## Memorandum

Winnetka Park District

Subject: Special Use Permit Review #1 – Centennial Park + Beach 255 Sheridan Road – (Case No. 24-08-SU) Review Responses (WPD)

Sheet No. C142

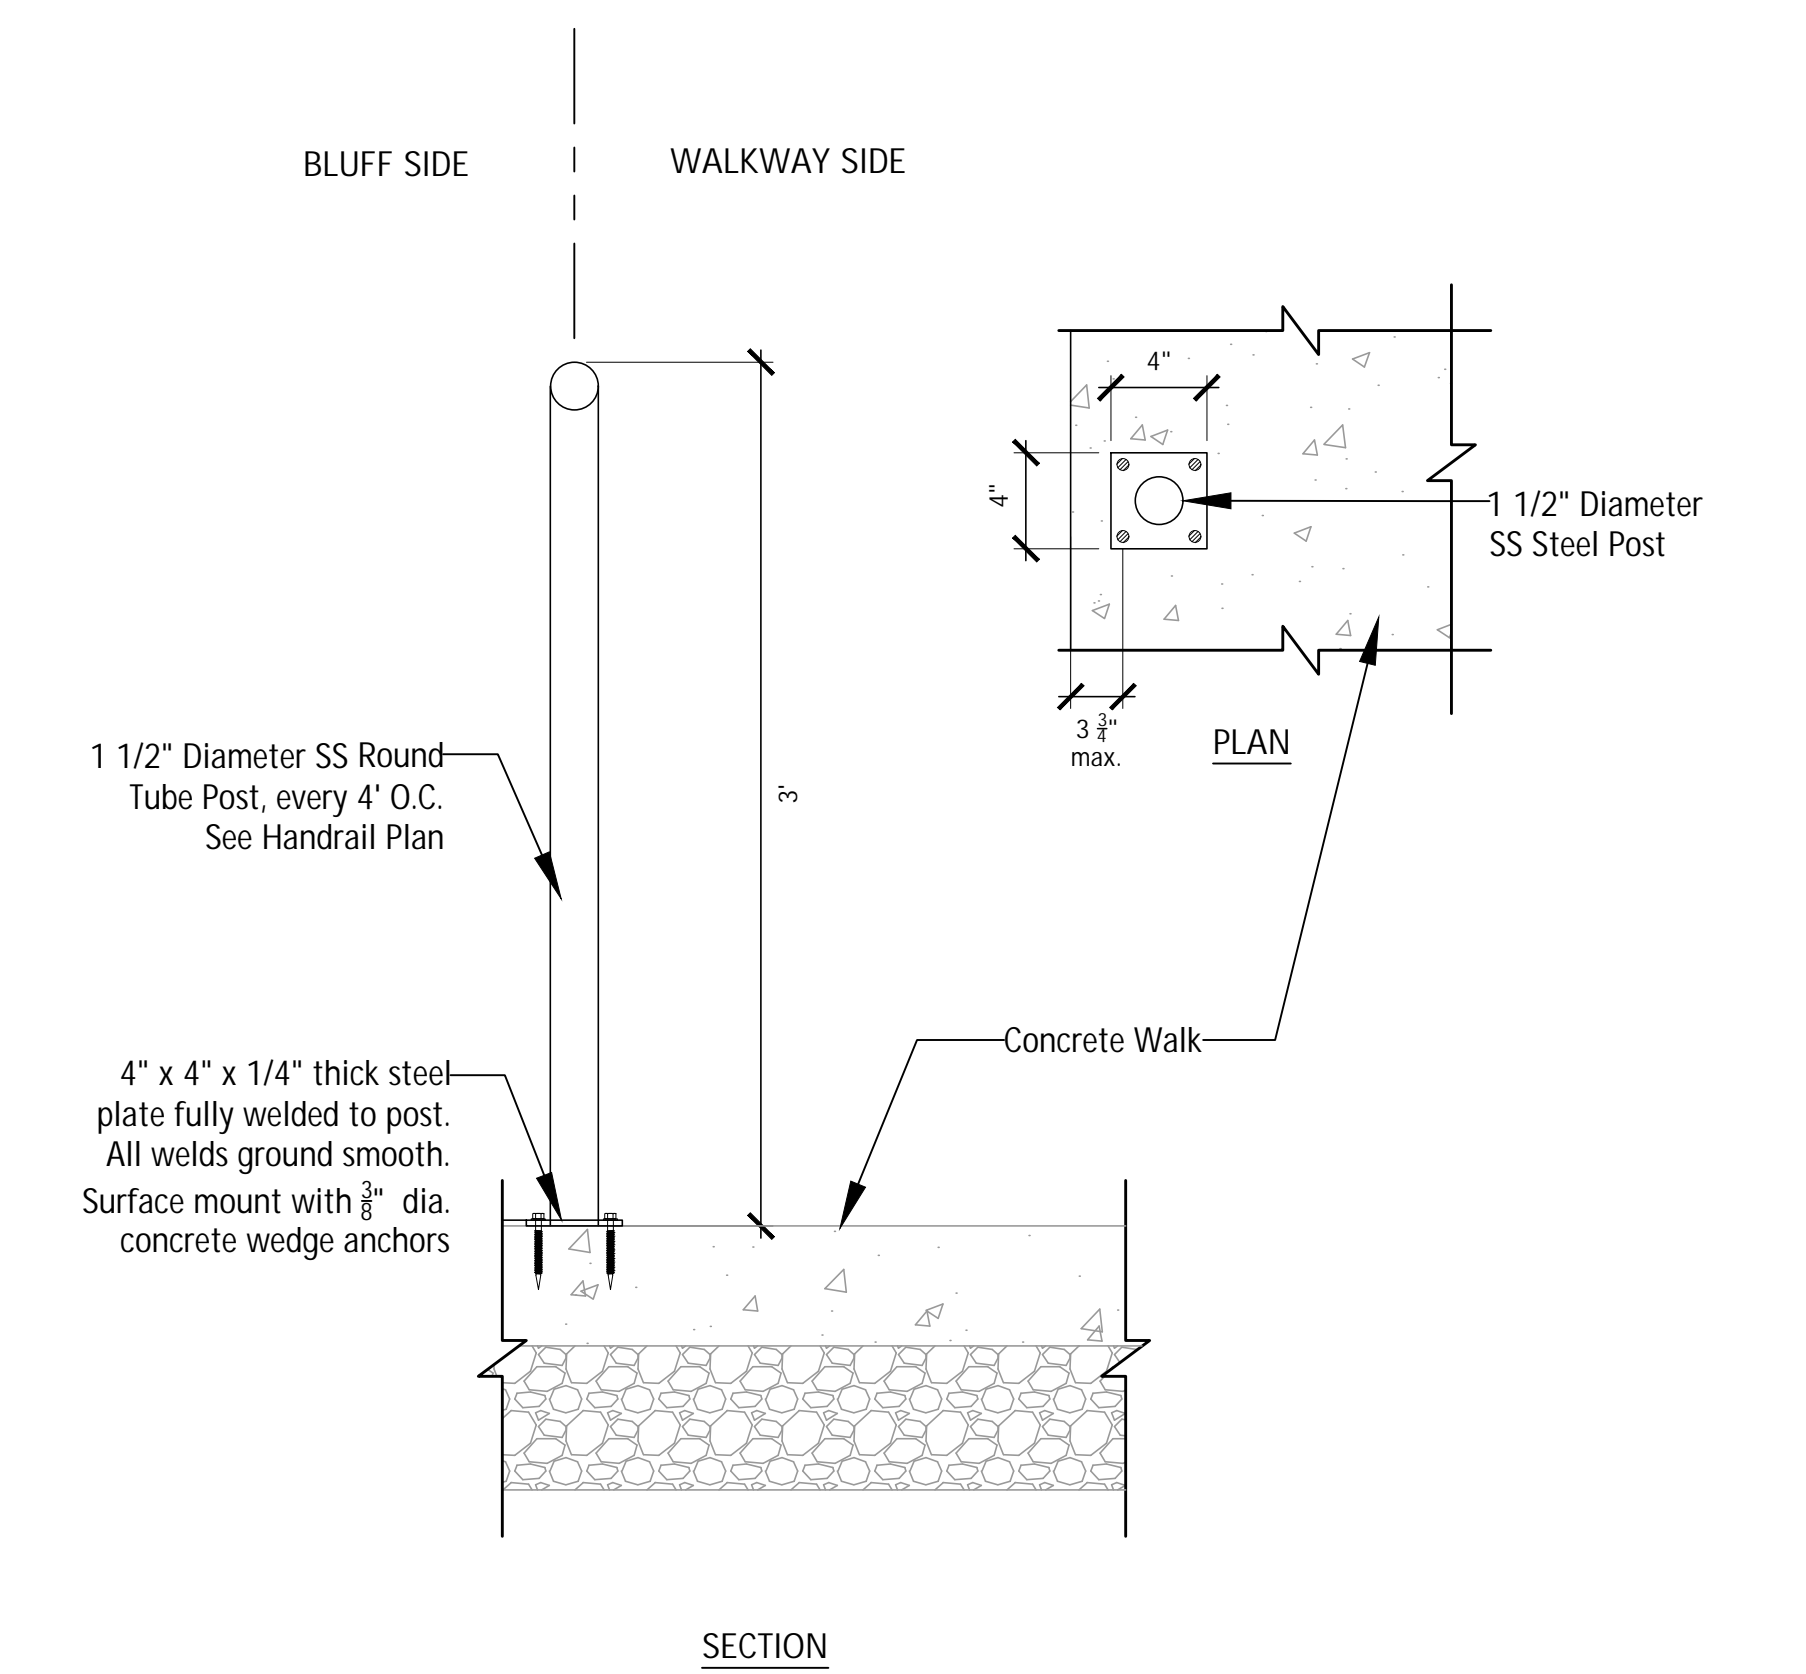
25. Provide details on how the boardwalk would be constructed and what it would be constructed of.

**Response: Boardwalk structure details are provided on the engineer's drawings. Details for the material and finish of the boardwalk are provided on sheets C142.**
